DAUPHIN COUNTY SUBDIVISION/LAND DEVELOPMENT REVIEW REPORT

Municipality	West Hanover Township		Surveyor	Melham Associates, PC		Engineer	Rettew		
Plat Title	449 North Fairville Avenue								
Zoning District	I: Interchange Zoning District			Proposed Land Use		Outdoor Storage			
Plat Status:	Preliminary		Plat Type:	Subdivision		Regulations:	County		
	Final			Land Development			☒ Municipal		
	☒ P/F			☒ Combined			☒ Zoning		
	Minor						☒ S&LD		
# of Lots	2	# of New Lots	1	# of DUs		Acreage Subdivided/ Developed	18.84	Total Acreage	18.84
Date Received	09/19/2024		Staff Review	10/1/2024		Official County Review	10/1/2024		
Reviewed by	BW		Checked by			Parcel No:	68-020-008-000-0000

Project Description: Construct an outdoor storage area with associated office and workshop space

Plan No. 24-099

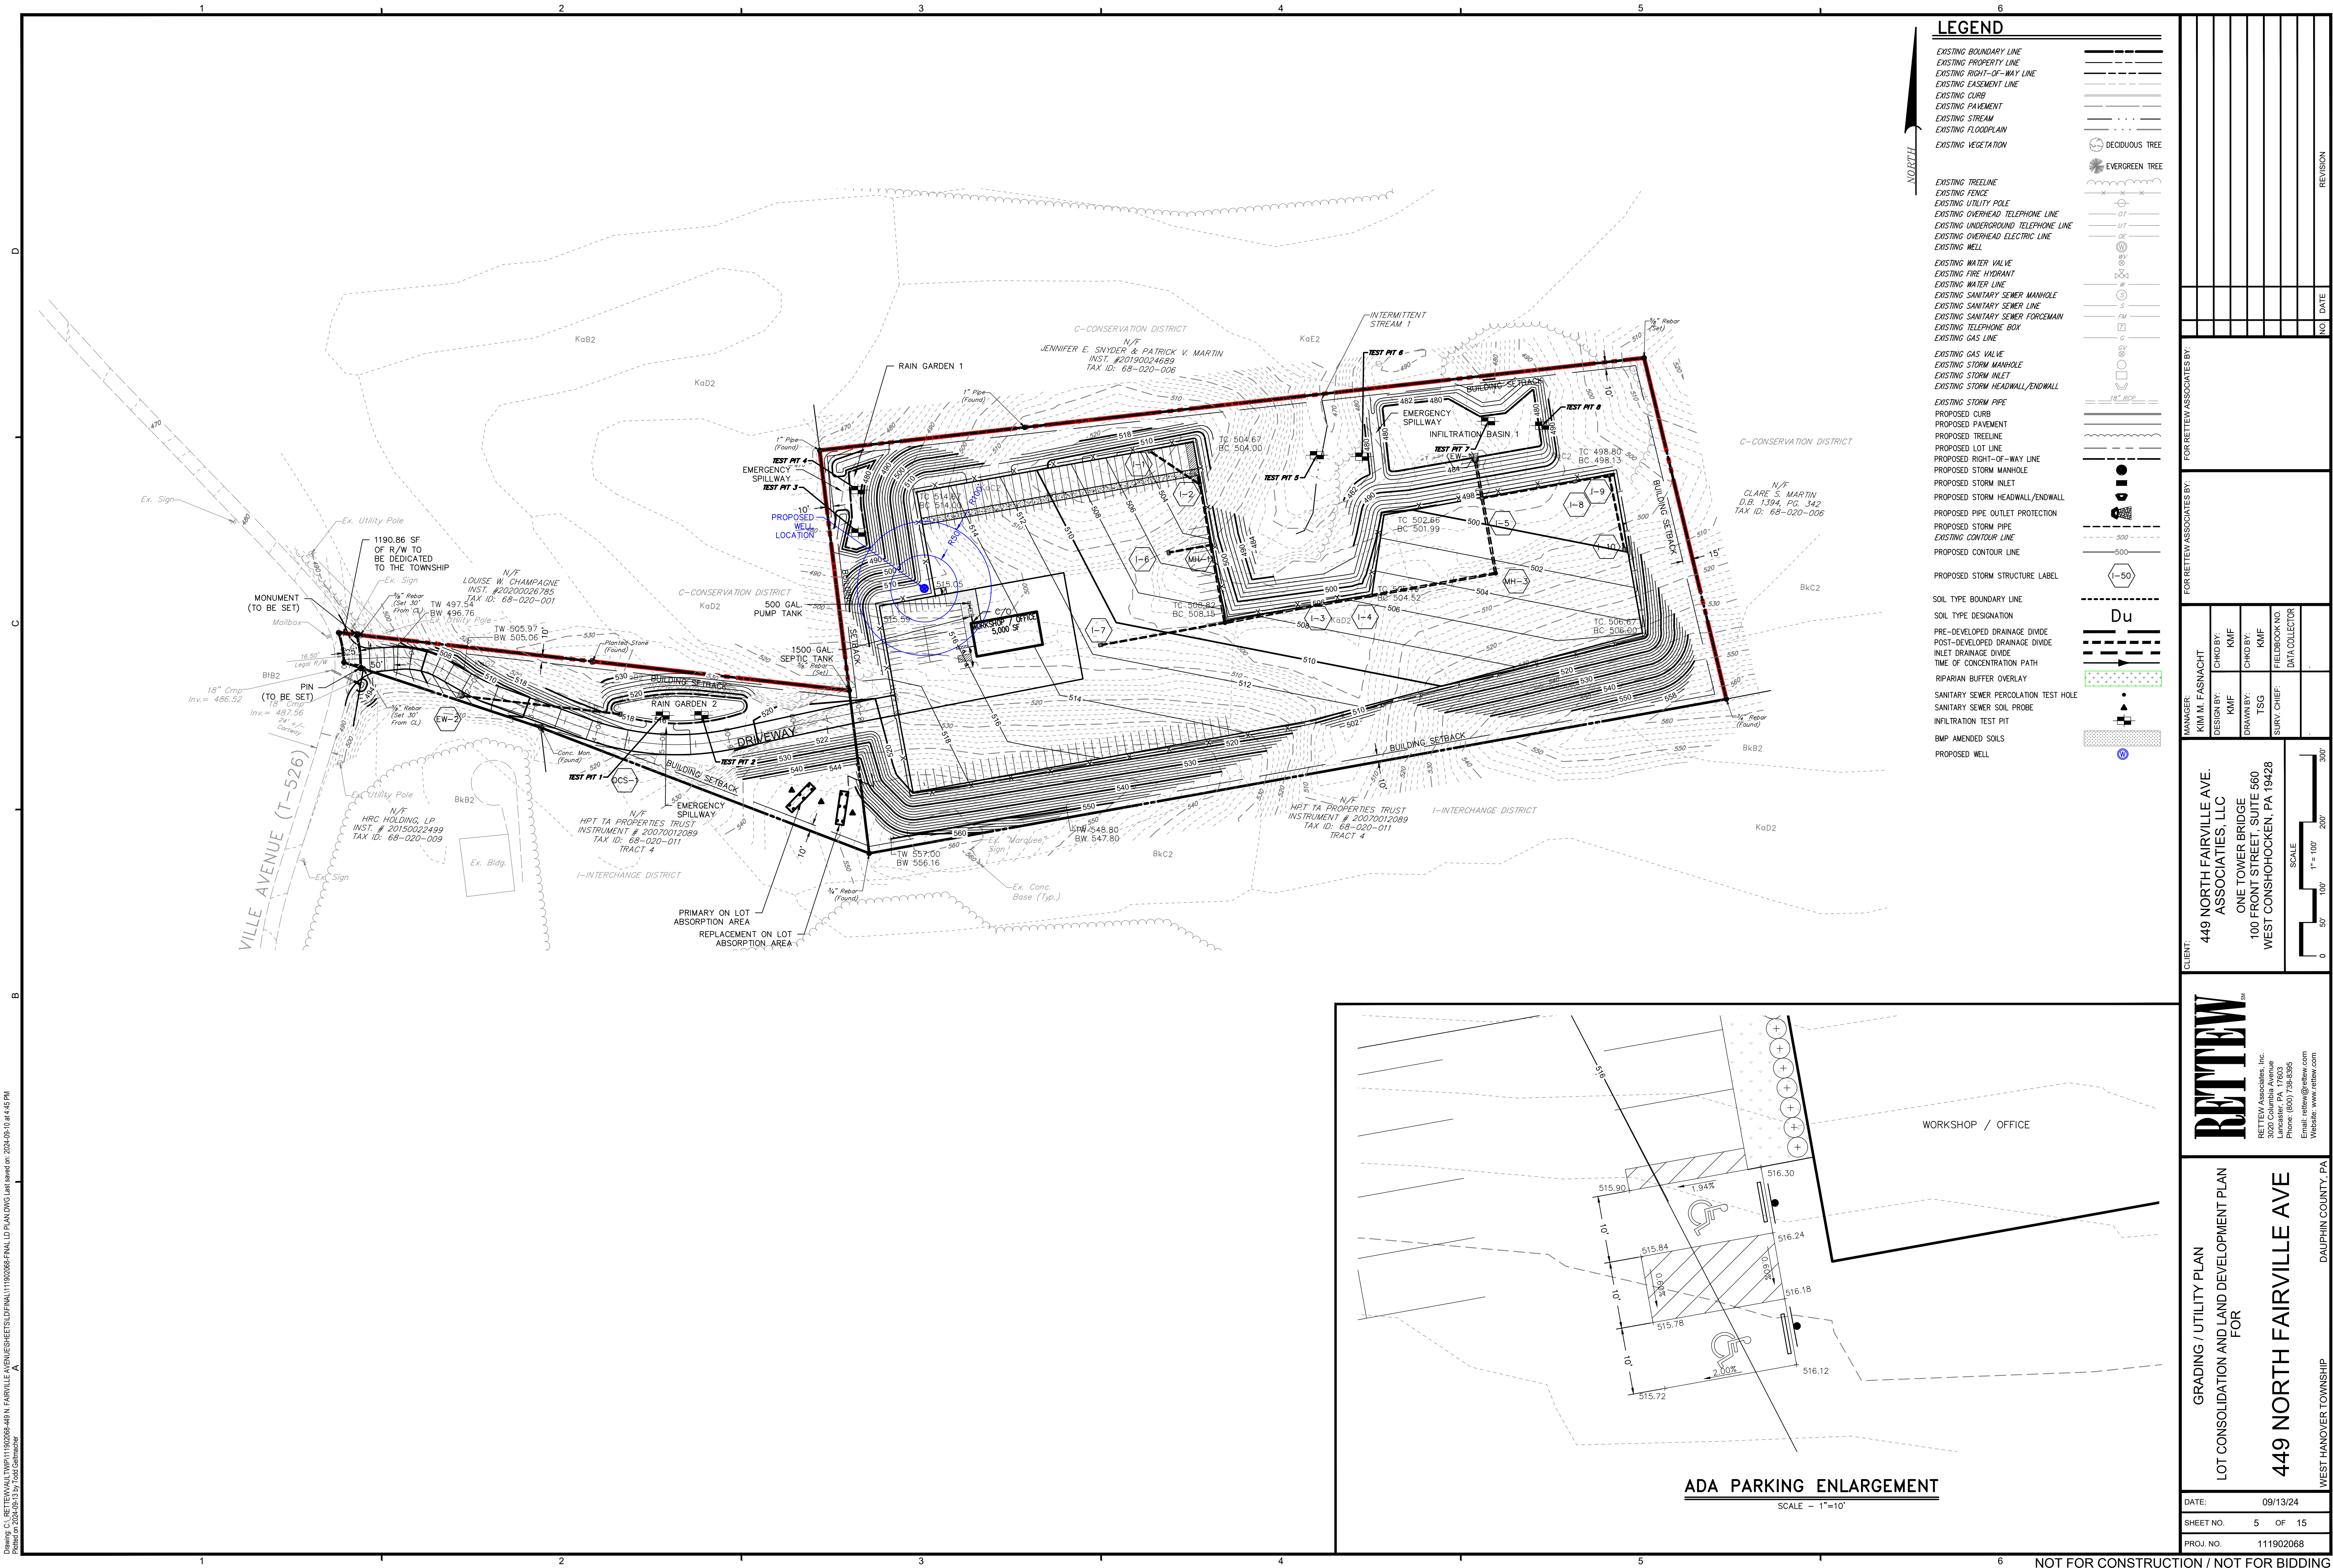
3. Proposed Driveway locations depicting sight distance and clear sight triangles shall be displayed and in accordance with § 173-25L(10) [S-LD § 173-15-B-29]
